Department of Energy
Albuquerque Operations Office
P.O. Box 5400
Albuquerque, New Mexico 87115

UMTRA PROJECT OFFICE
PROJECT INTERFACE DOCUMENT

Site Tuba City	Date 18 Jan 1990	PID No. 18-S-14	Site No. 18	Vic Pro No.
Originator and Location D. M. Bolton, SFO	Phone (415) 442-7586	Organization MKES	Answer By:	References: Subcontract: Subcontract No:
Subject Revision to Tuba City S&M Subcontract Documents

FIGURE 1.2
 FINAL SITE CONDITIONS
 TUBA CITY, ARIZONA, DISPOSAL SITE

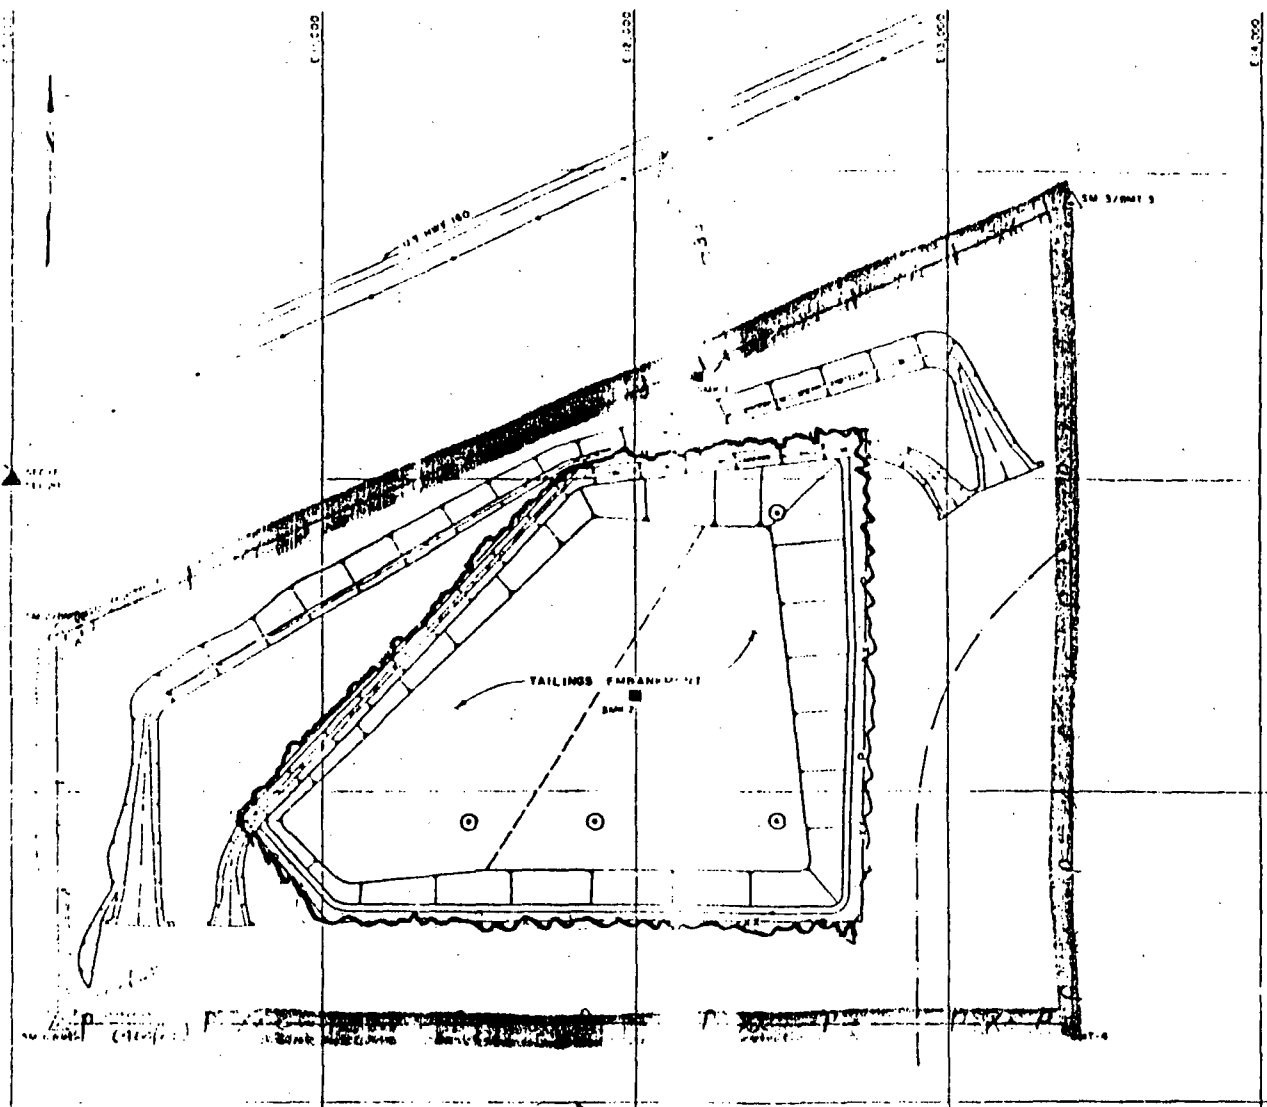
The U. S. Department of Energy (DOE) requests MK-Ferguson Company (MK-F) to relocate the planned "disposal cell fence" at the Tuba City disposal site as shown on enclosed drawing number TUB-PS-10-0834. Refer to Project Office letter to you dated August 3, 1989. The requested location places the fence on the disposal site boundary.

The planned location of the fence prevents future access to the disposal cell by DOE surveillance and maintenance teams. Furthermore, the perimeter signs should be located, as specified below, at the perimeter of the disposal site boundary (not around the disposal cell as currently planned). Additionally, the requested location of the fence will protect these signs and other permanent features from vandalism and theft. Relocating the fence as shown will require the following additional changes:

1. An access gate should be placed at the site entrance coincident with the road to the site from US 160 as shown on the attached figure. Note that the final position of the gate should allow vehicles to enter the site.

2. The site marker (SMK-1) should be installed immediately to the left or right of the gate (inside the fence) but should not restrict vehicular traffic into the disposal site area.

3. The entry sign should be installed on a post (highway standard or equivalent) behind the fence, immediately adjacent to the gate. The U. S. Nuclear Regulatory Commission has requested that the entry and perimeter signs for all disposal sites be installed on posts behind the fence(s), rather than attached to the fence, to discourage theft.

4. The perimeter signs, installed on posts behind the fence, should be placed as indicated on the attached figure. Since the signs have been placed to guarantee visibility, as per the Guidance Document (DOE, 1986), additional signs will, therefore, be needed.

5. The boundary and boundary/survey monuments currently placed at the corners of the disposal site property should be offset inside the fence.

Since the survey/boundary monuments also will be used here to measure displacements for the four settlement plates, the amount of offset required for these monuments should be sufficient to permit their use in measuring the displacements with ease.

Solution: Revise Spec. No. 01055 (Monuments and Surveys), Spec. No. 02850 (Signs), Spec. No. 10421 (Site Markers), Section 00310 (Bid Schedule) and Dwg. No. TUB-PS-10-0834, Rev. 0 to conform to the DOE directive.
